**15/00833/LBC (CT.2547/X)**

**H S B C  
2 Market Place  
Cirencester  
Gloucestershire  
GL7 2NS**

**Replacement external ATM, removal of railings and stone steps and new internal  
ATM with associative works  
at H S B C  
2 Market Place Cirencester**

<b>Listed Building Consent 15/00833/LBC (CT.2547/X)</b>	
Applicant:	HSBC Banking PLC
Agent:	HLN Architects Ltd
Case Officer:	Joanna Lishman
Ward Member(s):	Councillor Joe Harris
Committee Date:	10th June 2015

*Elevation of HSBC Bank, Cirencester.*

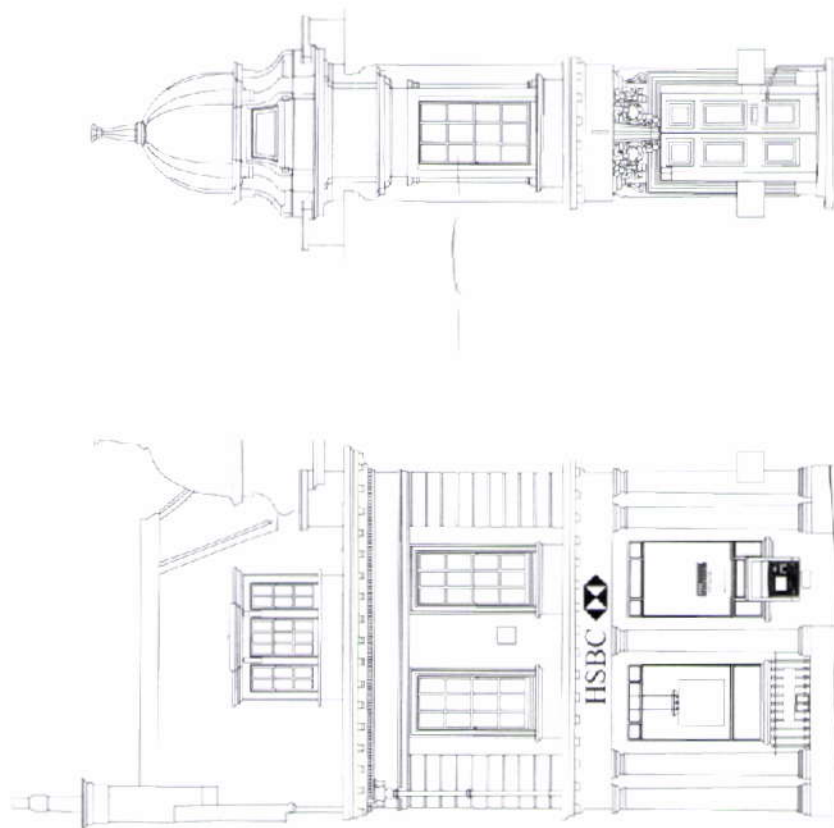
The current proposal is to lower the ATM, to facilitate wheel-chair access, but includes the cutting out of the remainder of stereobate and its associated railings for the entire width of this intercolumniation (the gap between the two columns).

As well as constituting primary historic fabric, the stereobate (definition: the foundation or base upon which a building or the like is erected) comprises a fundamental part of the elevational design of the building; it is the visual plinth upon which the engaged Doric columns rest, and in classical architecture is as fundamental to the composition of the columns as the entablature that they support.

Whilst this portion of the stereobate has already been compromised by the present step, further and more extensive erosion would only exacerbate the existing level of harm.

Additionally, the removal of the remainder of the stereobate and its associated railings would further visually distinguish this bay of the building from the originally matching bays, both to the left, and on the return façade, thus further harmfully eroding the simplicity of the original composition, which had only two types of bay, the window bay, that was repeated five times, and the curved door bay on the corner.

Consequently the further removal of the stereobate and associated railings would harm the character of the listed building.

The principle of lowering the ATM is, in itself, uncontentious; however it would entail further disruption to the historic fabric of the wall, it is not proposed to remove any of the large stone insertion that was installed the original ATM, nor to align the ATM in any way to respect the architectural design of the building, to provide some mitigating conservation benefit. Inserting the ATM very slightly (around 100 mm) lower than is currently proposed would allow both for the removal of the late-20th-century stone box, and the reinstatement of the window sill to its historic form.

The proposed alterations, by reason of their design and physical impact, would further erode the classical architectural composition of the historic façade, harming the character and special interest of the listed building, and unsuccessfully preserving or enhancing the character and appearance of the surrounding conservation area, thus failing to sustain the significance of either designated heritage asset. The proposal therefore conflicts with Section 12 of the N.P.P.F., and Policies 15 and 42 of the Cotswold Local Plan.
